FIELD SERVICE BULLETIN

FSB Number: LVCCFSB2005-230 (Rev B)
Author: Darwin Garcia
Date: August 18, 2005
Total No. of Pages: 3
Subject: **GSM Razr V3 SIM pin broken**
Model Affected: V3
Level of Repair: 3 & 4

Fig 1. A SIM Block pin in the front row is broken.

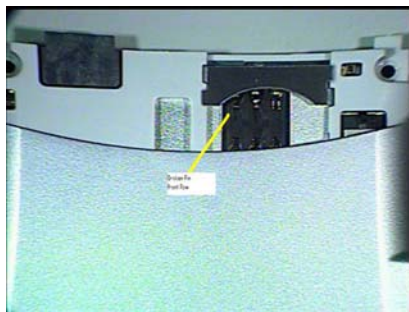
Service is aware that some V3 Razr units have been returned with complaints related to SIM detection. In several cases, service personnel have reported broken/bent pins in the SIM connector. The failure mode analysis indicates that the angle of insertion during SIM placement plays a fundamental role in the SIM connector damage.

Fig 2. Housing with protective tab.

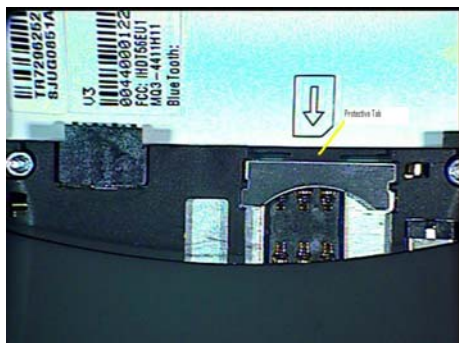
Short Term: A protective tab has been added to the back housing to prevent the user from bending or destroying the SIM connector front pins. The tab forces the SIM to run in parallel with the SIM connector's surface. The new rear housing was initially implemented at the factory in units built on black Razrs.

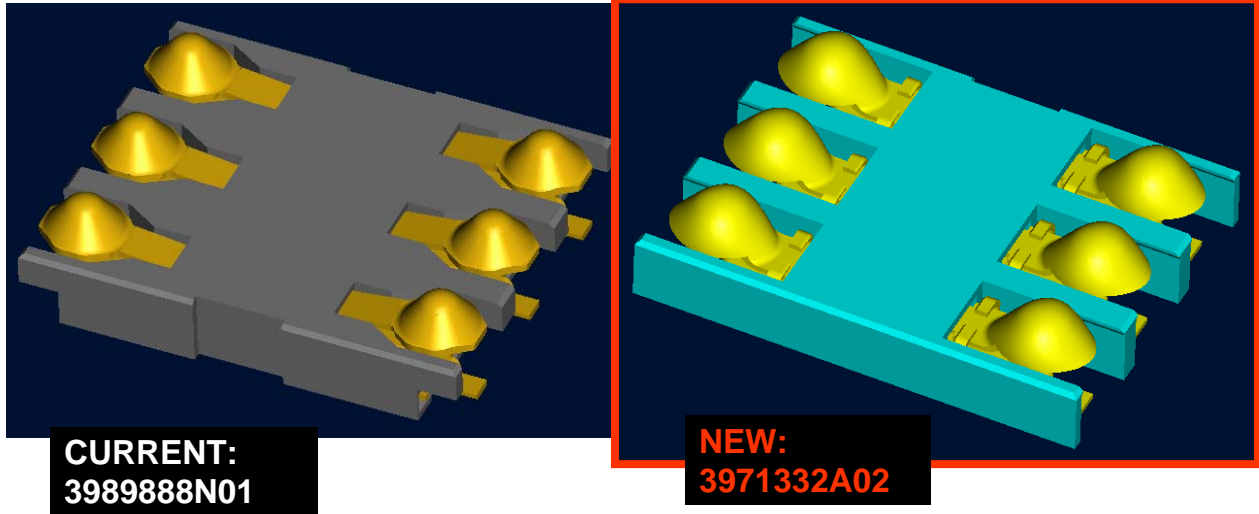
Long Term: As of August 12th new production units will include a new Molex connector, the design change features a more dome shape (R0.80 compared to ~R0.60) contacts and lowered leading edges (~0.25mm) to promote lead-in for SIM card insertion.
